Transport Assessment Second Addendum

Land north of Balcombe Road,
Haywards Heath

- 1.1.1 This addendum to the Transport Assessment (December 2025 ref. SDP-TA-131125-02) has been prepared following the response from West Sussex County Council dated 10th June 2026 providing further comments on the submitted documents. The response received can be found in Appendix A.

Date 20.12.24	Scale 1:500	Drawn NM
Drawing No. SDP-XX-XX-DR-D-305		Revision P8

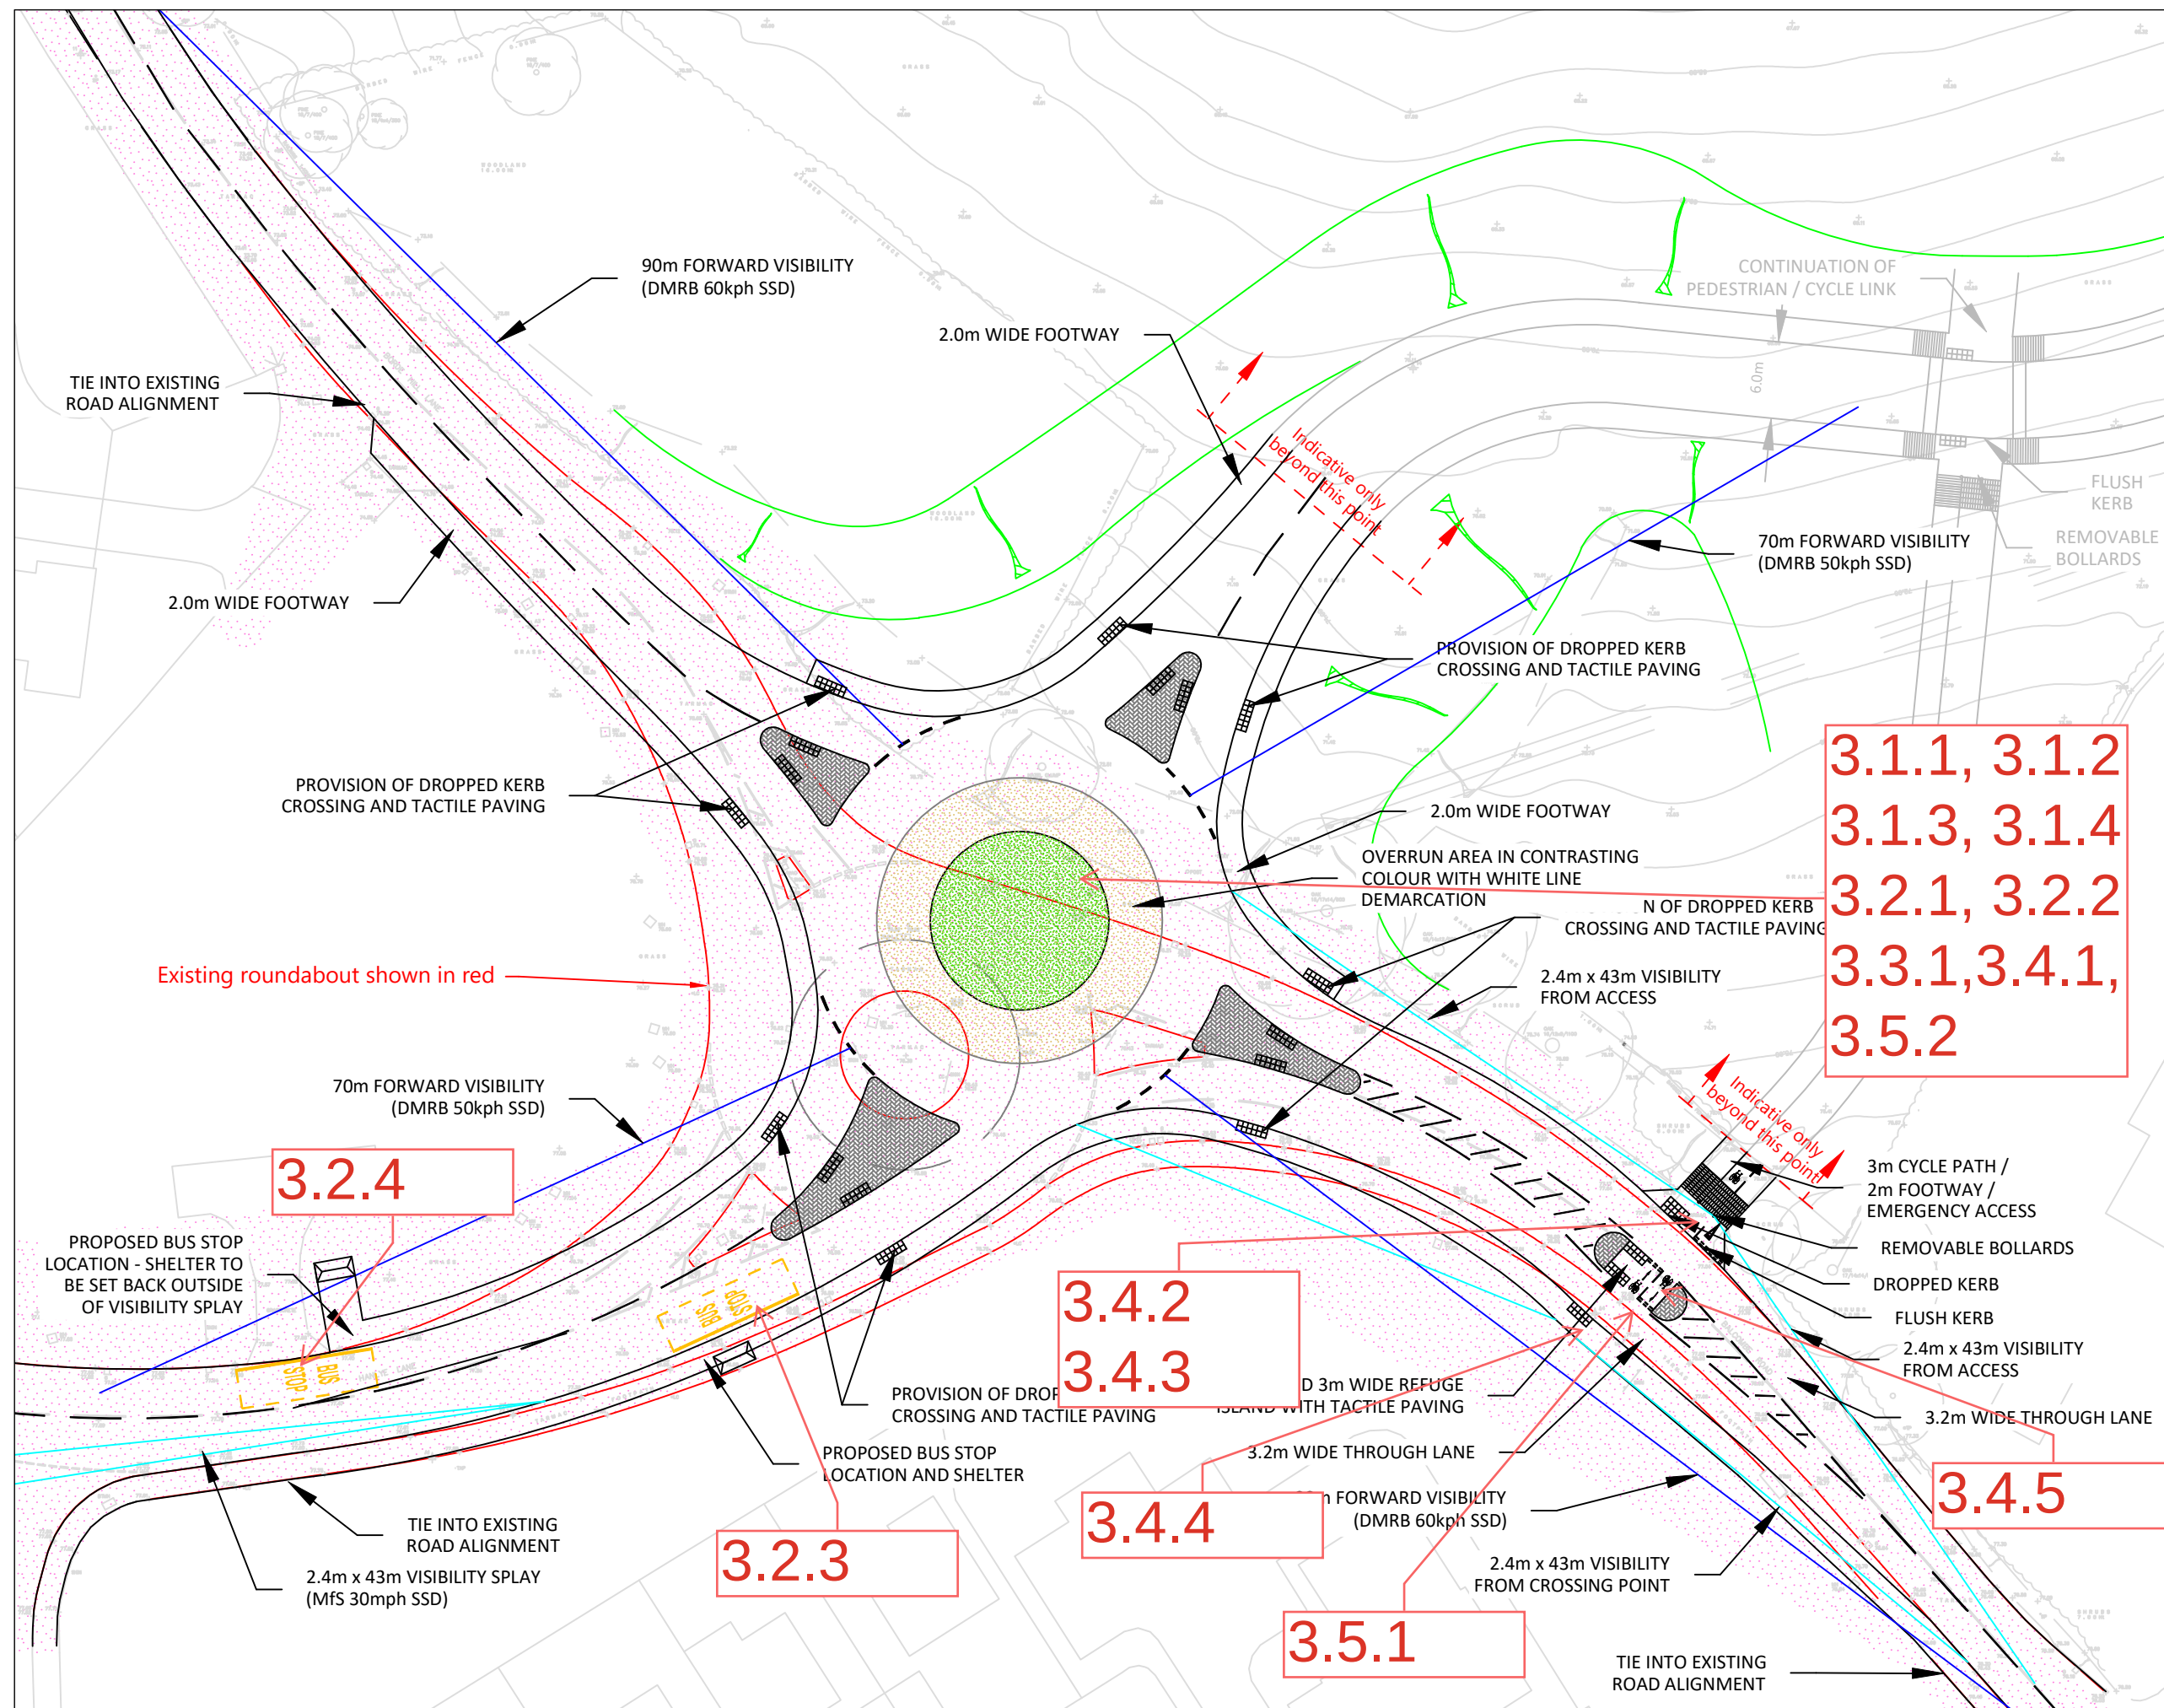
A bus stop is proposed on the southern side on Hanlye Road, buses servicing the bus stop are close to the exit from the roundabout, this could lead to queues tailing back onto the roundabout and possible rear end shunt collisions.

It is recommended that the bus stop is relocated further west remaining outside the visibility splay from Coniston Road and inset.

A bus stop is proposed on the northern side Hanlye Road., and on a slight carriageway curve. There is concern that vehicles will attempt to overtake the stationary bus, which could lead to possible head on collisions on the curve.

It is recommended that the bus stop is inset.

Shared use cycleway facilities that start and end and do not appear to connect with other networks or have facilities to leave or rejoin the carriageway. This could lead to cyclists riding on the footways and possible cycle to pedestrian collisions.

It is recommended that cycle facilities should link or that facilities should be introduced to allow cyclists to leave and rejoin the carriageway.

The proposed crossing point does not have a cycle take off facility for cyclists wishing to cross and enter the development, this could lead to cyclists slowing or stopping on the main line carriageway resulting in rear end shunt collisions, or vehicle to cycle collisions.

It is recommended that a 'jug handle' arrangement should be provided.

- 2.2.1 The updated audit of the layout shown on Drawing SDP-XX-XX-DR-D-305/P8 can be found in Appendix B. The recommendations for modifications to the bus stop arrangement and cycle access have been progressed following this audit and are discussed further in the following sections and are shown on Drawing SDP-XX-XX-DR-D-305/P9.
- 2.2.2 It is considered that all points raised in the Stage 1 Road Safety Audit can be positively addressed at the detailed design stage.

- 2.5.1 Amended details have been provided on Drawing SDP-XX-XX-DR-D-305/P9 for the proposed cycle access. WSCC require a 'jug handle' arrangement on the northbound approach to the site access. This has the benefit of taking cyclists off the carriageway prior to crossing Balcombe Road and would reduce the risk from rear-end shunts for cyclists travelling northbound on Balcombe Road, and wanting to access the cycle route.

- 2.6.1 The Road Safety Audit recommended that the westbound bus stop on Hanlye Lane be relocated further west to reduce the potential of any queue tailing back onto the roundabout. The bus stop has now been moved further west, whilst remaining outside the visibility splay from Coniston Road. It is not possible to inset the bus stop due to highway boundary restrictions.
